# Keystone RV Company

## SAFETY ADVISORY # 20-381

### Carbon, Cougar, Fuzion, Impact, and Raptor Fifth Wheel TV Antenna

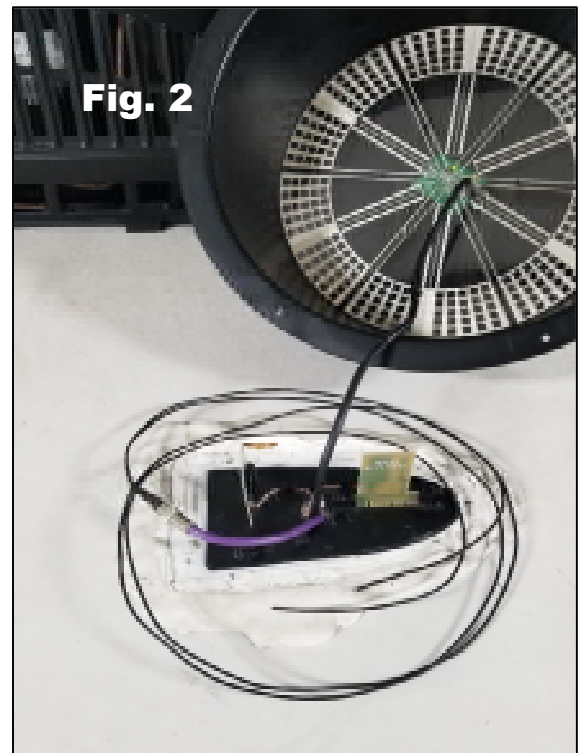
Locate the mounting base for the Furrion antenna and remove the exterior 7 screws to detach it from the roof. Remove the 4 screws out of the bottom of the base and pull the mount for the 4G antennas out of the base, Figures 1 and 1a. Discard the unused portion of the mounting base.
